# *City of Afton*

## **Natural Resources and Groundwater Committee (NRGC)**

## Carlson PLCD feedback from Susan Winsor, NRGW committee

RE: Carlson Proposed PLCD on 60<sup>th</sup> Street West of Trading Post Trail -Sketch Plan dated January 17, 2017 (Carlson 60<sup>th</sup> Street PLCD or PLCD)

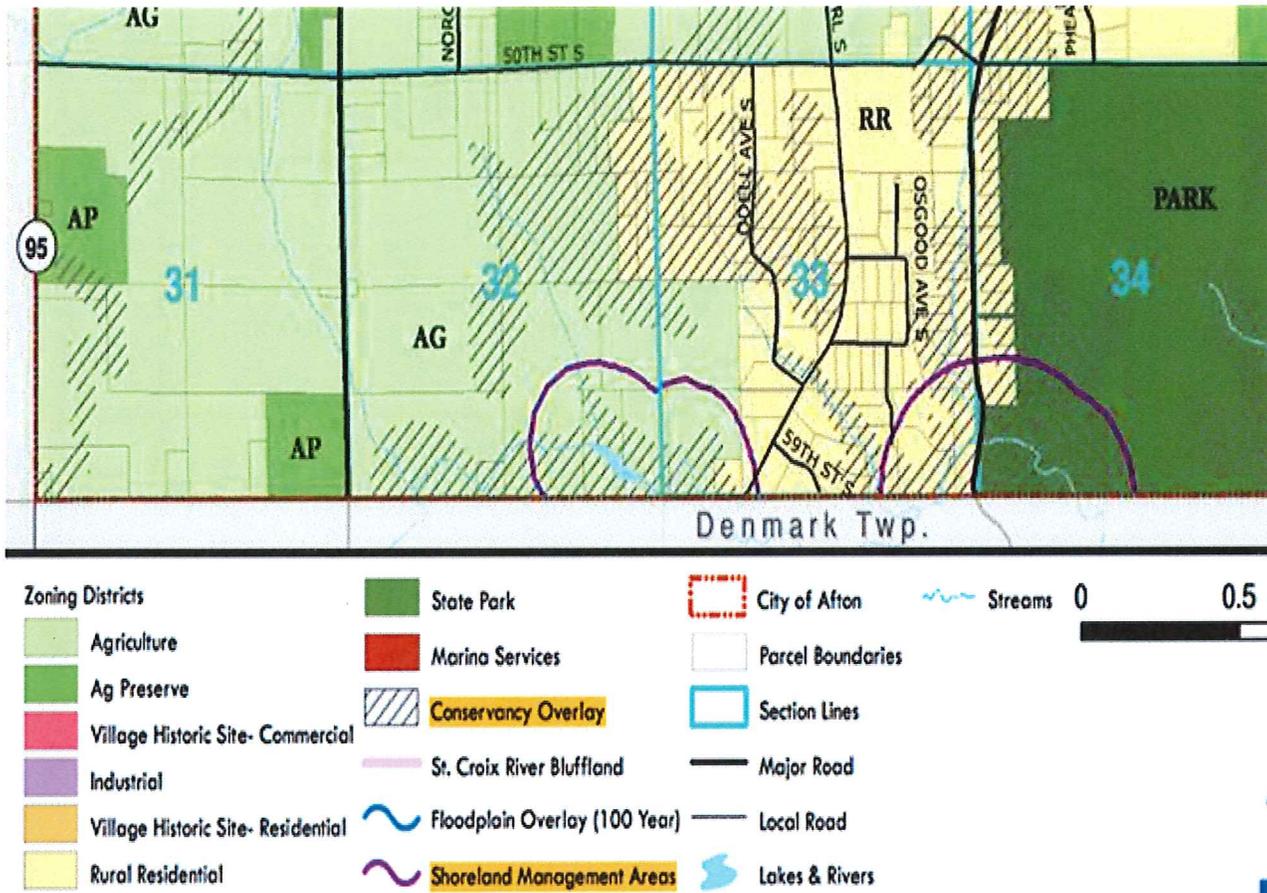
Superimpose the Conservancy Overlay District and the Shoreland District on this plat in order to fine tune these recommendations below, in order to reduce erosion and stream/river contamination:

\*Remove Lots 1, 2, and 3 due to concerns about erosion into trout stream and river nutrient contamination. These appear to lie in the Conservancy Overlay District, and in part, in the Shoreland District.

\*Convert Southwest corner of plat, South of stream, to Afton parkland as parkland dedication fee. Append any land that exceeds the 7.5% of land value stipulation to the Open Space Conservation Easement.

\*Lots 4 & 5: Add parts with slopes above 13% to the 10-acre adjacent Open Space immediately to the West, and the remainder comprises one lot instead of two, if eligible per Afton zoning laws. These appear to lie in the Conservancy Overlay District, and in part, in the Shoreland District.

\*Lots 9 and 10: Append to adjacent Open Space Conservation Easement for reasons of slopes above 13% grade.

\*Lots 14, 15 and 16: Add those lot portions with slopes exceeding 13% to the adjacent Open Space to the North. Remaining portion comprises one lot, or whatever the remaining less steep landscape represents.

\*Run plat past local watershed and Minn. DNR (Shoreland District part of it) for feedback on lot placement relative to slopes and trout stream.

Afton NRI  
Figure 1.1

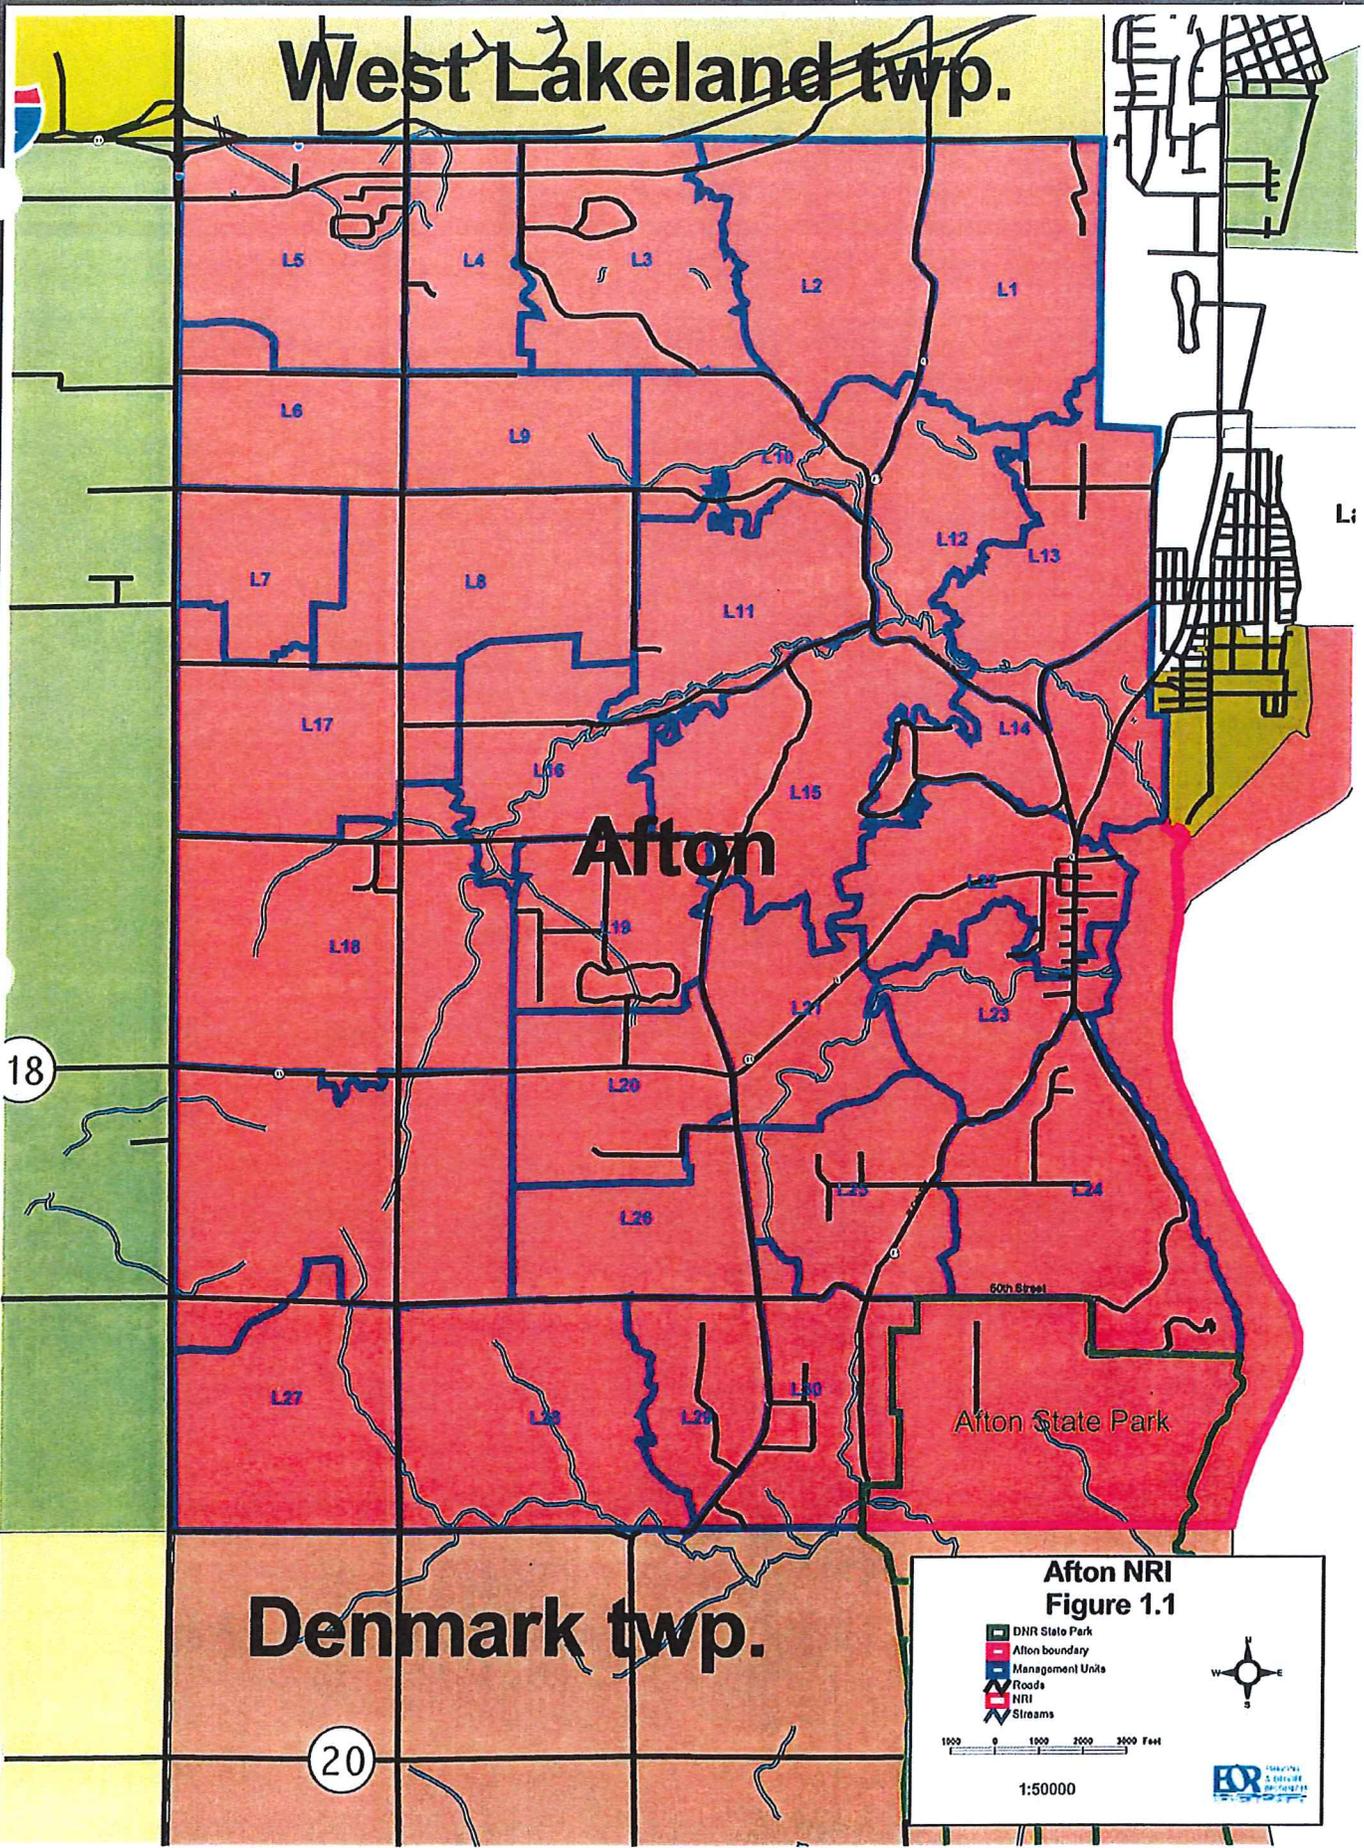
- Background/relevant context: per *Afton Natural Resources Inventory Final Report 2001* (pg. II-2) the PLCD, encompassing L28 and L29 of said report (see attached "Land Unit map"), has landscape rankings as follows:

- Review Table II.2 Major Management Issues - L28 and L29 have majority level of concern ranked at top two levels (medium and high). Report back with plan to address these sensitivities.

- Review Table II.3.Stewardship Strategies outlined for L28 and L29. Report back with plan addressing these stewardship strategies.
  - L28 is listed under Table II-4 Priority Resource under "Key Natural Resources Management Recommendations" due to its ranking of highest quality/most unique landscape units within the City. Recommended action is as follows:

- Headwaters of Trout Brook 1. Group of bedrock knobs contains prairie remnants that offer good restoration potential. Further survey should be conducted to determine management approach. 2. Evaluate headwaters pond (flood retention pond) to determine thermal impacts to brown trout survival/reproduction. If significant thermal impacts are shown to exist, work with landowner to remove structure, restore seepage wetlands and reestablish thermal/hydrologic regime to Trout Brook.

- Provide the City with plan addressing above stated concerns.
- For reasons stated above, an Environmental Impact study of the proposed development needs to be conducted with the above report in mind, to help identify areas of concern (potential negative impact to Trout Brook and regionally significant ecological areas - terrestrial and wetlands). Additional considerations of existing steep slopes to be addressed as well. It is recommended that said impact study be conducted by reputable third party and presented to NRGW committee for review.
